Program Bulletin

Bulletin No.: 12052 Date: April 2012

SUBJECT: Convertible Top Enhancements

MODELS: 2011-2012 Chevrolet Camaro

2709099

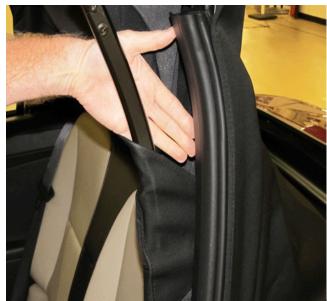
2. Starting at the top, reach behind the folding top cover material/headliner and position a piece of 3M Strip Caulk, P/N 08578 Black (1), or equivalent, to the side rear retainer.

2663906

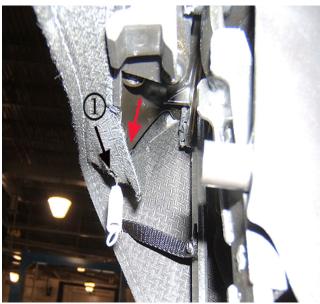
4. Pull the spring through the top cover material.

2663912

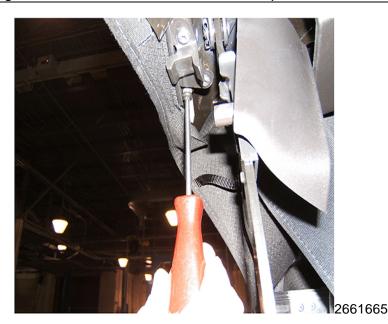
6. Reroute the cable spring through the hole (1) in the top cover material.
